January 7, 2002

Nunavut Water Board
P.O. Box 119
Gjoa Haven, NU
X0E 1J0

Re: Polaris Mine Decommissioning and Reclamation Plan – Response to Regulator Questions

Figure 4. Predicted and Observed Salinity of the Surface Layer of Garrow Lake 1980 – 2010

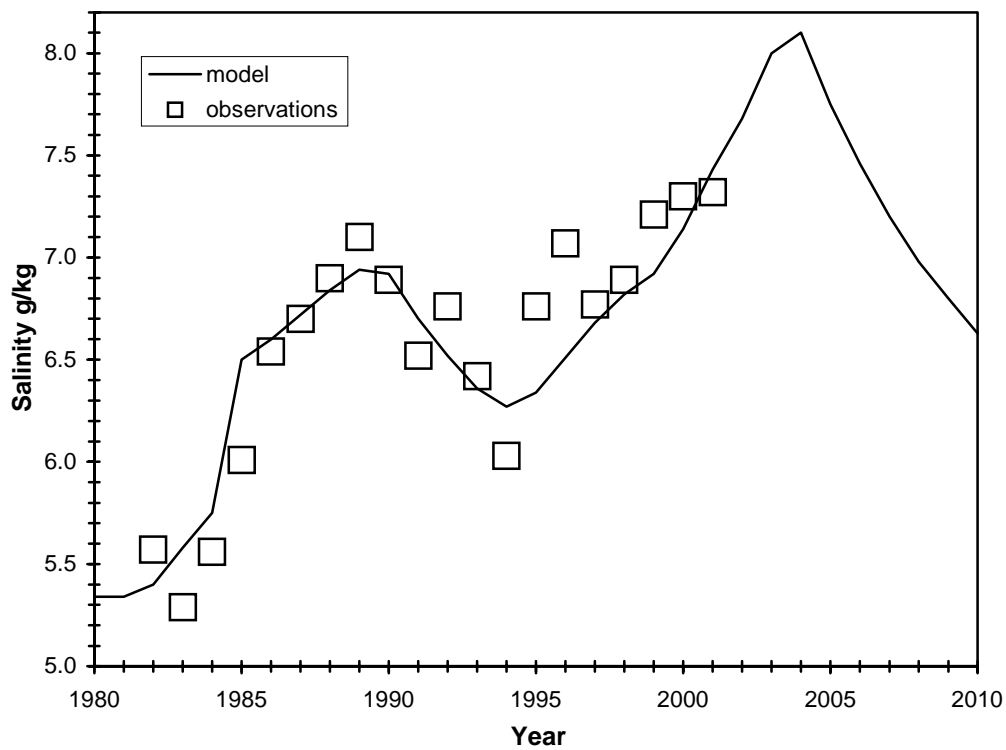
There was an error in Figure 4 of our report. This may have resulted in some confusion about what was stated on page 5. The vertical axis in figure 4 should read Duration in days not hours. The text on page 5 of the report which refers to Figure 4 is correct however.

UPDATED DOCK & SHORELINE SECTIONS

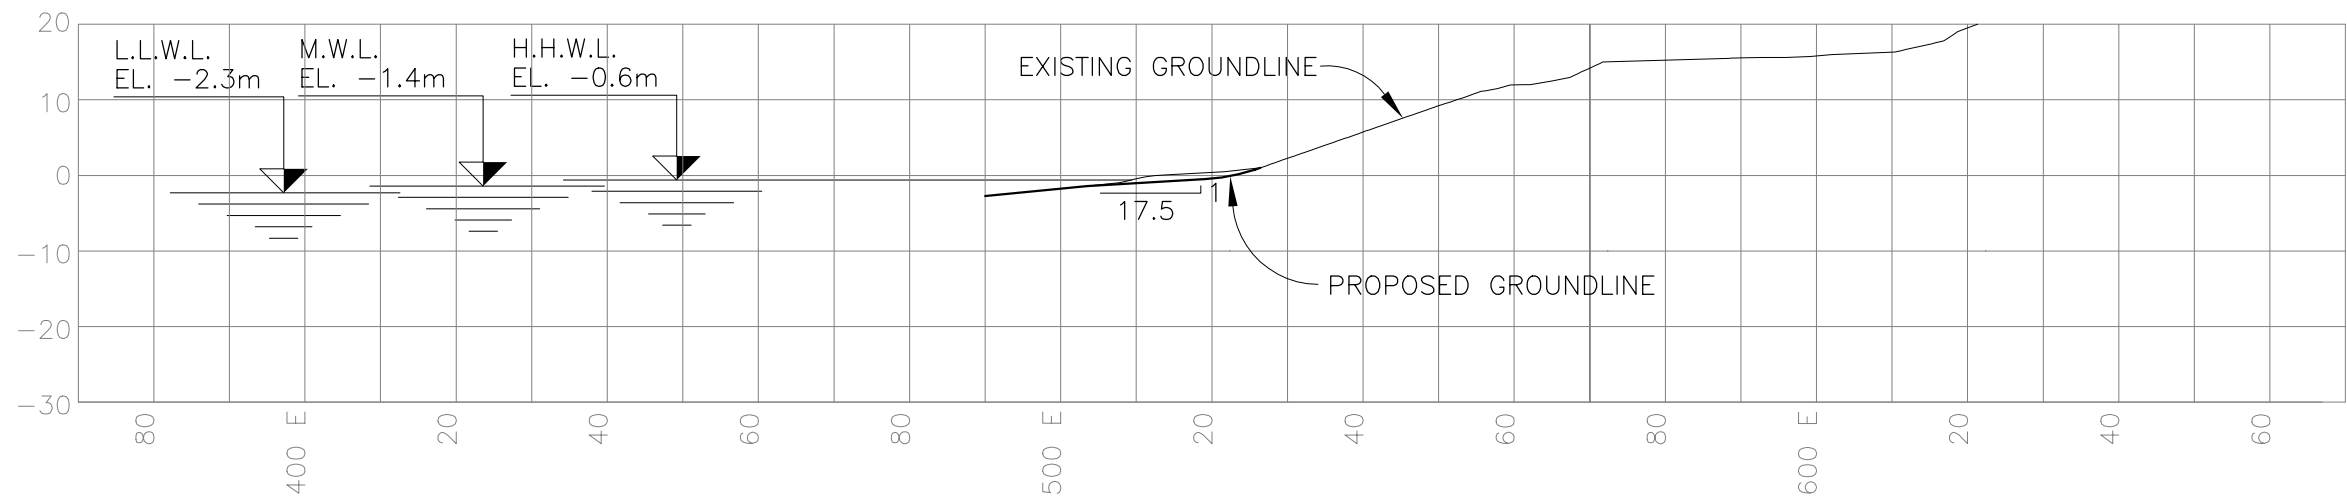
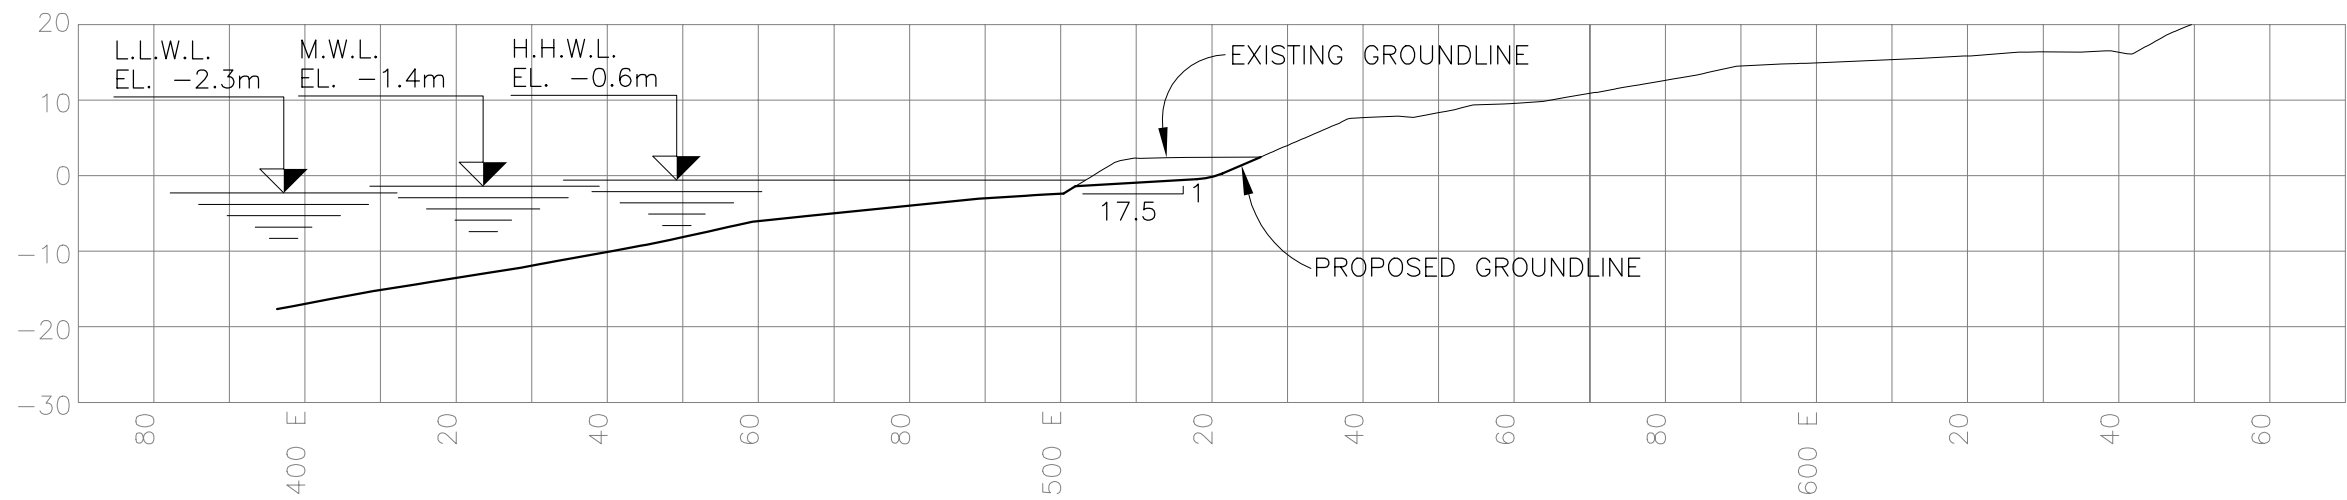
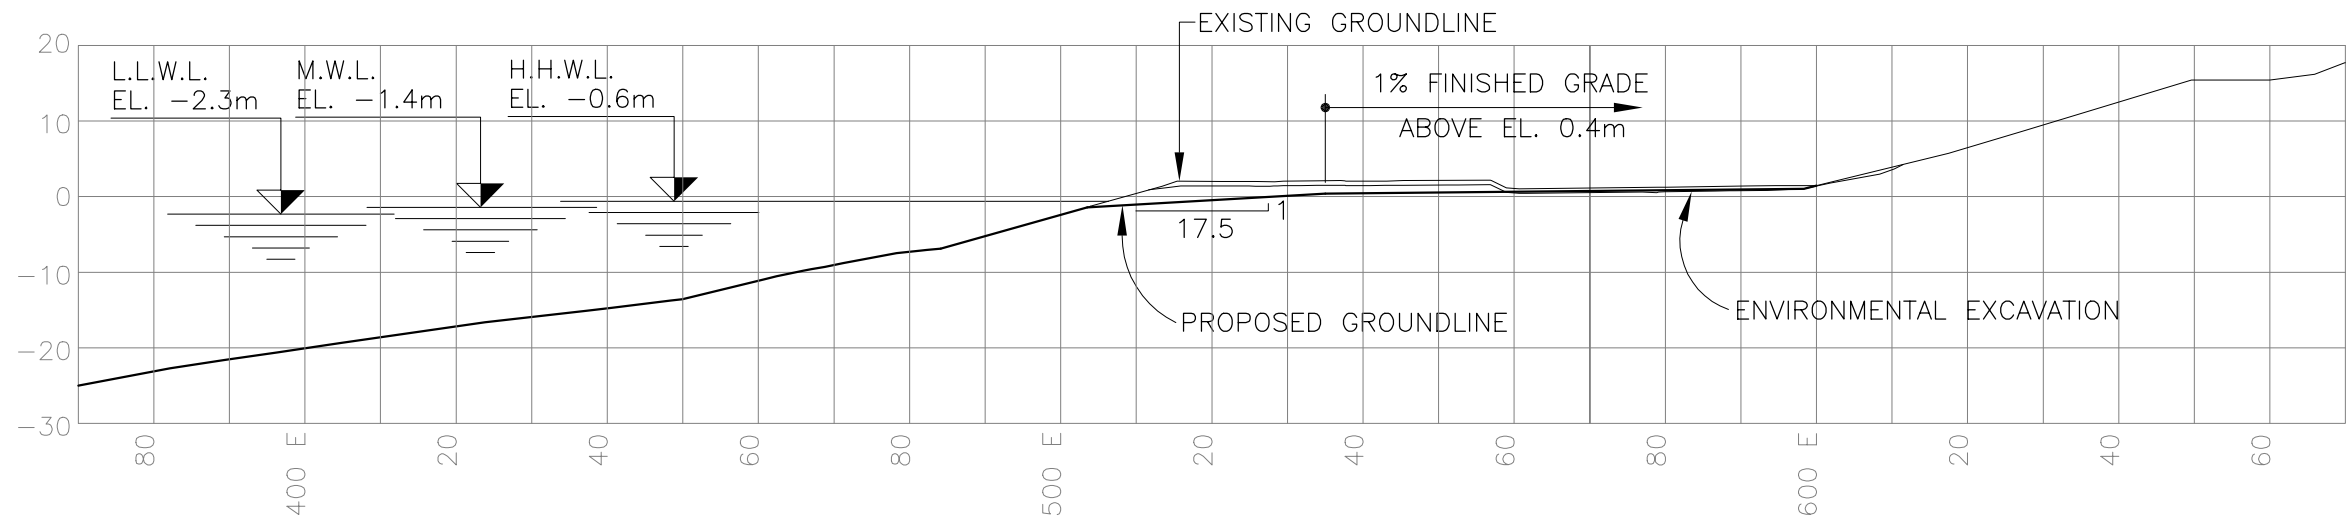
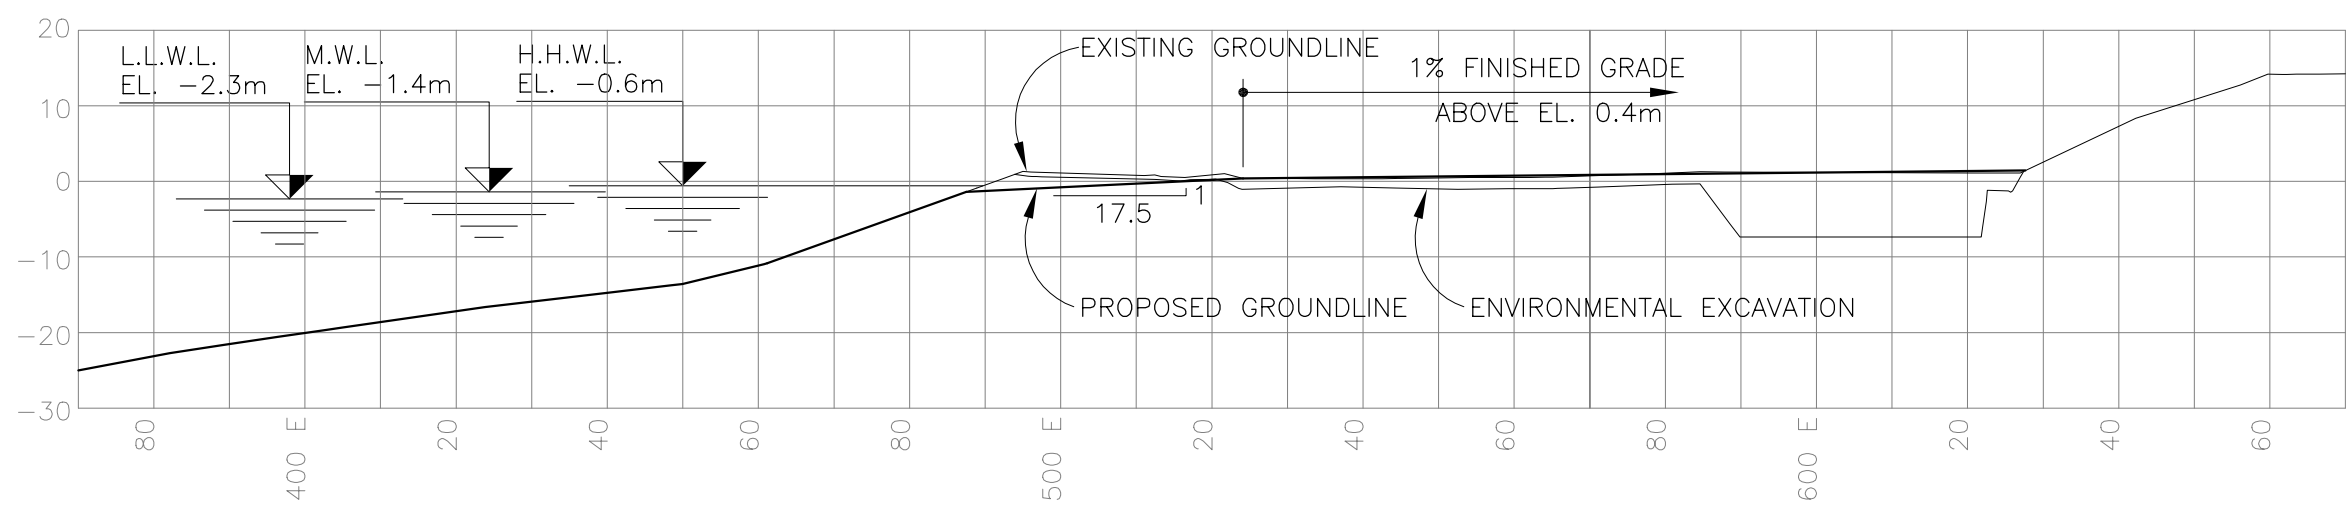
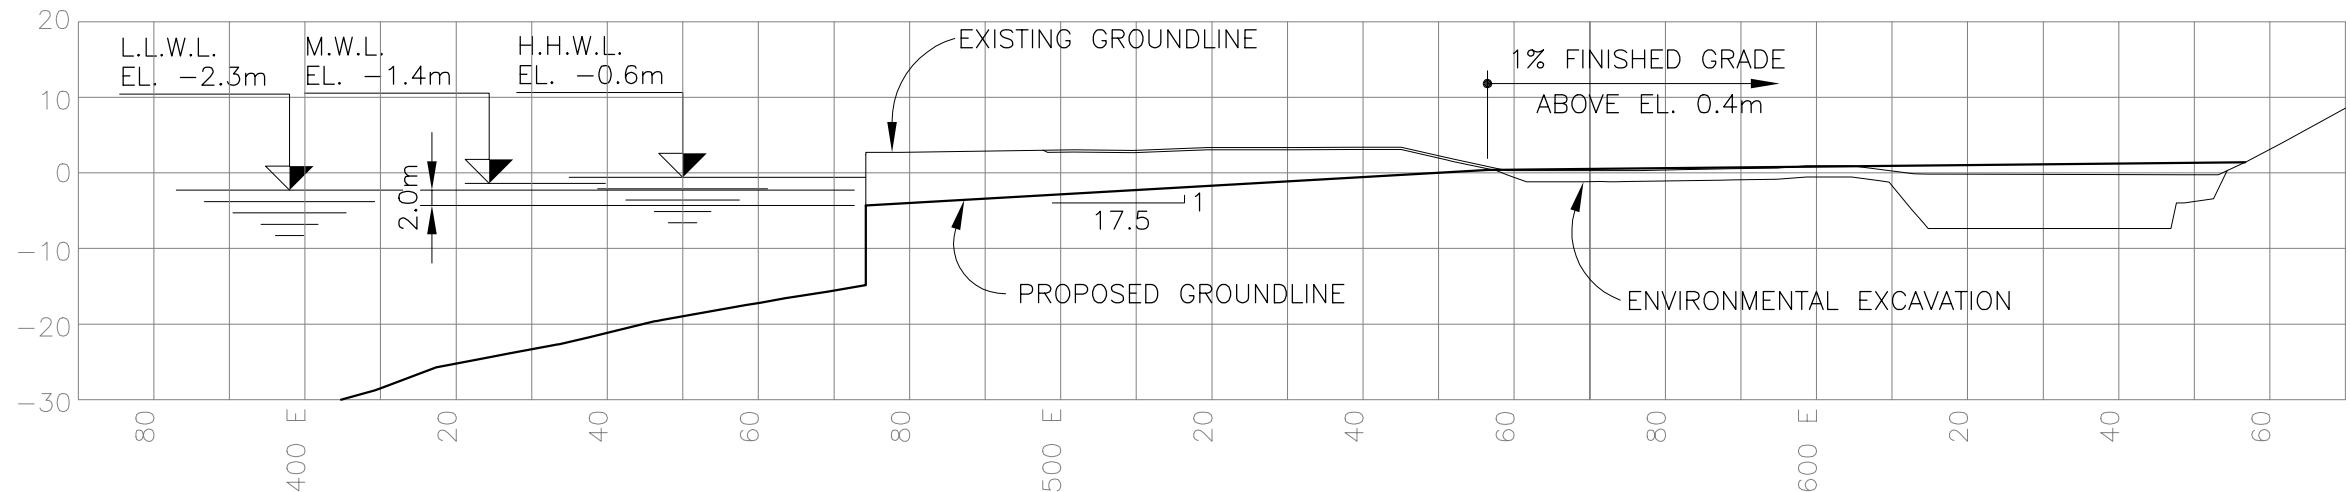
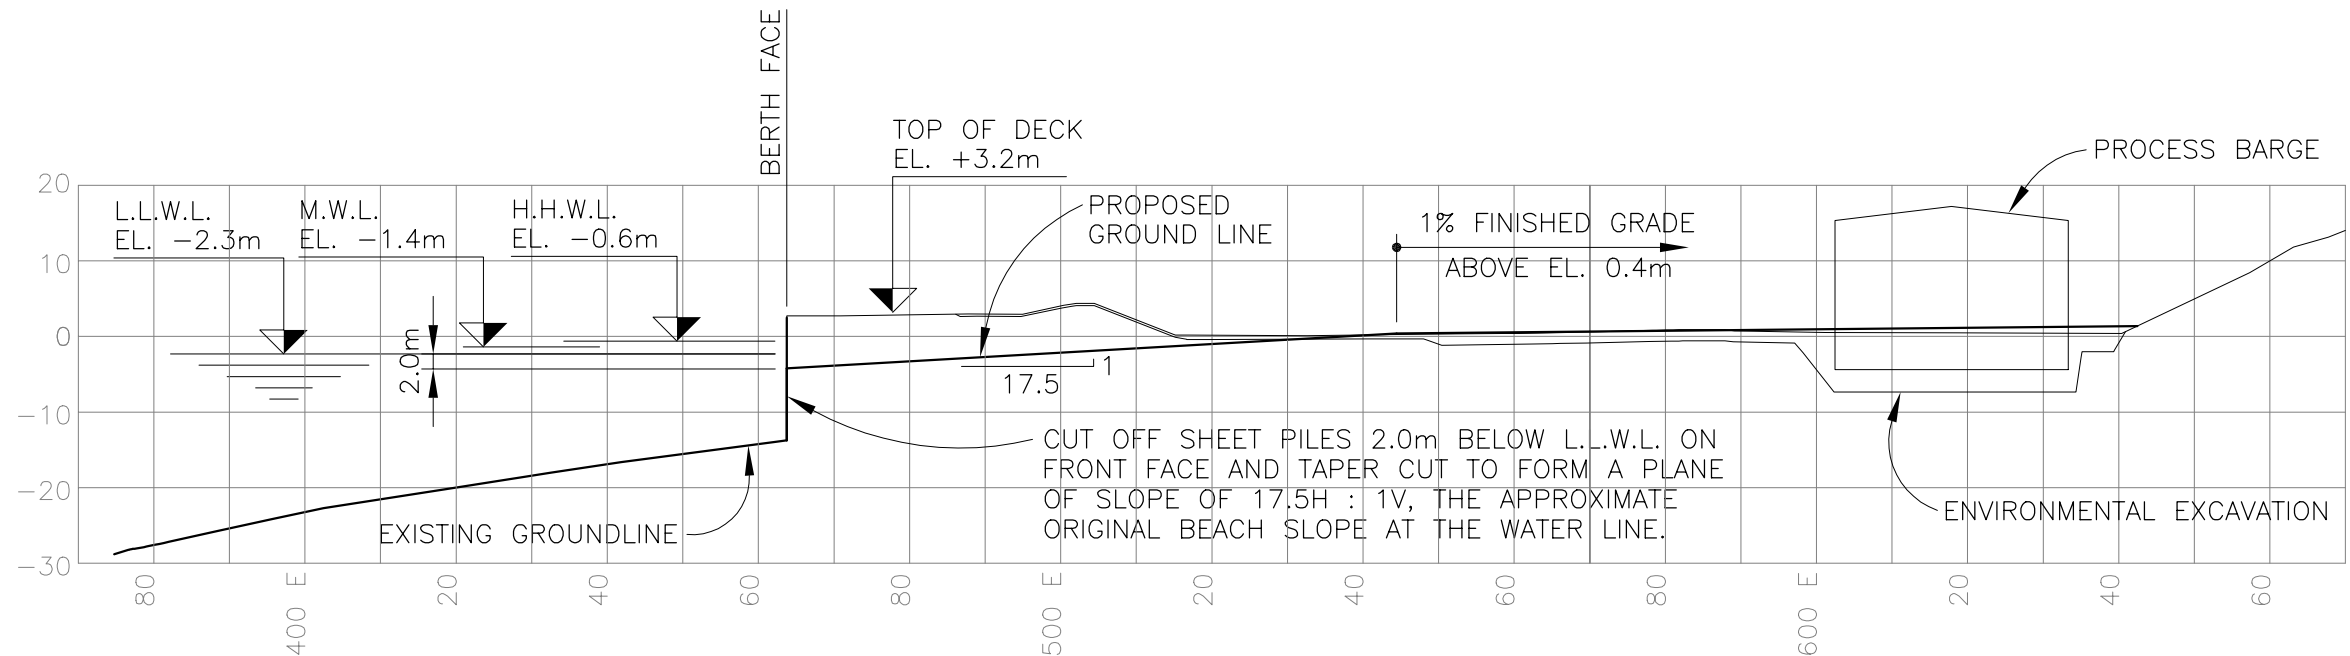
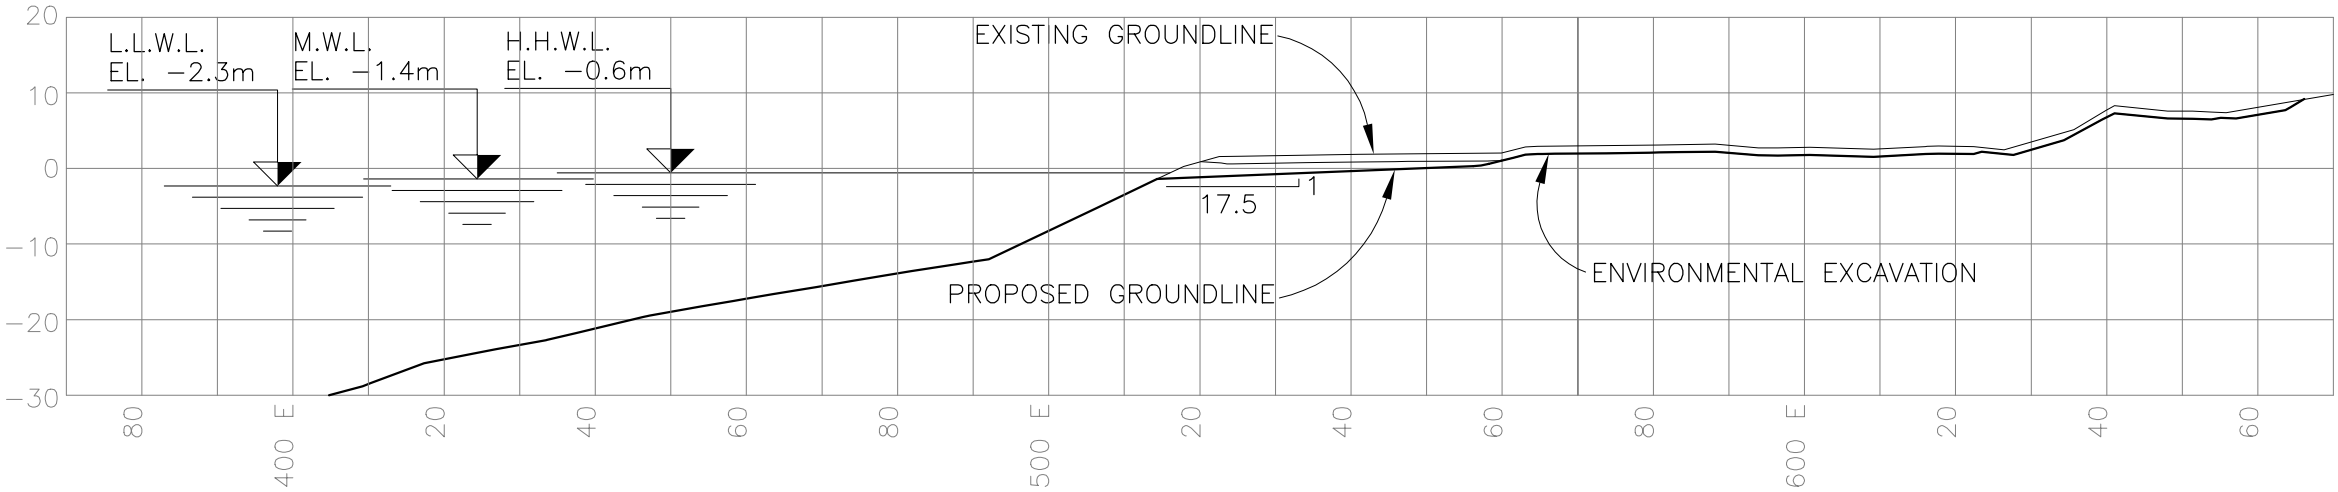
Decommissioning of the Dock - Although plans to remove the dock with recontouring of the shoreline to approximate natural shoreline slope is considered the preferred alternative, additional detailed, finalized construction information and finalized blasting plans are required.

In reviewing the drawings in Appendix D, a significant drop off (approx. 10 m) between the proposed ground-line and the existing ground-line will still exist where the dock sheet piles are presently located (see appendix D - sections sheet 3). The report states...”regardless of whether the sheet piles are cut-off or are extracted, the frozen fill will erode very slowly, and is not expected to have an impact on seabed habitat.” However, because of vertical face of the drop off at this location and since the material in this face (probably) contains fill used in the sheet pile cells, justification as to why this vertical face will experience gradual erosion while other areas are being re-graded to a 17.5V:1H slope should be provided.
